## NEBRASKA CAPITOL ENVIRONS COMMISSION STAFF REPORT

APPLICATION NUMBER Urban Design Record #24007

APPLICATION TYPE Certificate of Appropriateness

ADDRESS/LOCATION 401 S 14th Street and 1335 L Street

## ATTACHMENT B - Site Plan

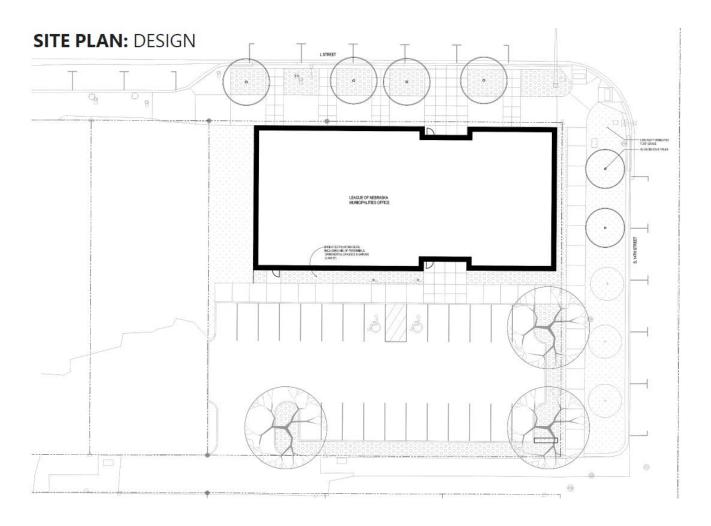
**Compatibility per Staff Analysis:** The parking in the rear is almost entirely hidden from view from the L Street side, and while it is visible from the S 14<sup>th</sup> Street side, the proposed landscape screening appears to effectively limit its impacts from the street, as well as from the alley and the adjacent property. Additionally, new street trees have been shown per the requirements of the design standards. It should be noted that the material provided by the applicant does not include a final landscape plan with specific species selection. Planning Department staff will work with Parks staff to ensure that all proposed plant species are acceptable prior to the issuance of a building permit.
